# Access Compliance Report

## Public Rights-of-Way

Intersection ID: 45510	Main Street: WOODLAND_WATCH_CT	Cross Street: MEADOW_BOTTOM_RD	Location: NW
ADA ID: 855377D688B3	Ramp Type: Perp	Initial Pass/Fail: Pass	Overall Compliance: No
Codes/Mitigation Info/Possible Solution			Severity Score: 5
			Field Measurements/Component Compliance

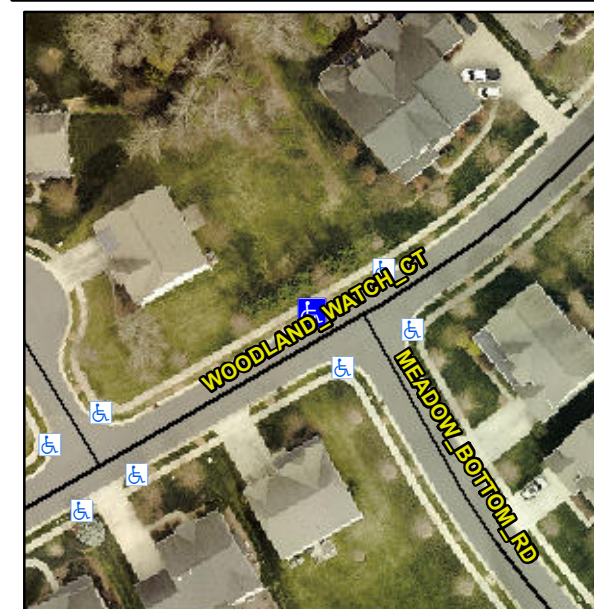
**Not Found, R304.5.4**

Compliance	Description	Data	Compliance	Description	Data
N/A	Ramp Length (in)	47.0	Yes	Ramp Slope (%)	8.0
Yes	Ramp Width (in)	48.0	Yes	Ramp XSlope (%)	0.9
N/A	Flare Type LT	Sloped	N/A	Flare Type RT	N/A
N/A	Flare Slope LT (%)	2.1	Yes	Flare Slope RT (%)	6.2
N/A	Flare Traversable LT?	Yes	N/A	Flare Traversable RT?	Yes
Yes	Landing Length (in)	48.0	Yes	DWS Provided?	Yes
Yes	Landing Width (in)	48.0	Yes	DWS Contrast?	Yes
Yes	Landing Slope (%)	2.0	Yes	DWS Length (in)	24.0
Yes	Landing X Slope (%)	1.4	Yes	DWS Full Width?	Yes
N/A	Landing Curb? (Y/N)	No	Yes	DWS Offset (in)	2.0
N/A	Shared Landing?	No			
Yes	Gutter Ponding?	No	No	Gutter Slope (%)	8.7
Yes	Gutter Lip Ht (in)	0.0	Yes	Gutter X Slope (%)	1.3
N/A	Painted X Walk1?	No	N/A	Painted X Walk2?	N/A
	X Walk 1 Direction	To SE		X Walk 2 Direction	N/A
N/A	X Walk 1 Width (in)	N/A	N/A	X Walk 2 Width (in)	N/A
	X Walk 1 Slope (%)	2.5		X Walk 2 Slope (%)	N/A
	X Walk 1 X Slope (%)	1.7		X Walk 2 X Slope (%)	N/A

**Remove & Replace Entire Ramp.  
Remove & Replace Gutter.**
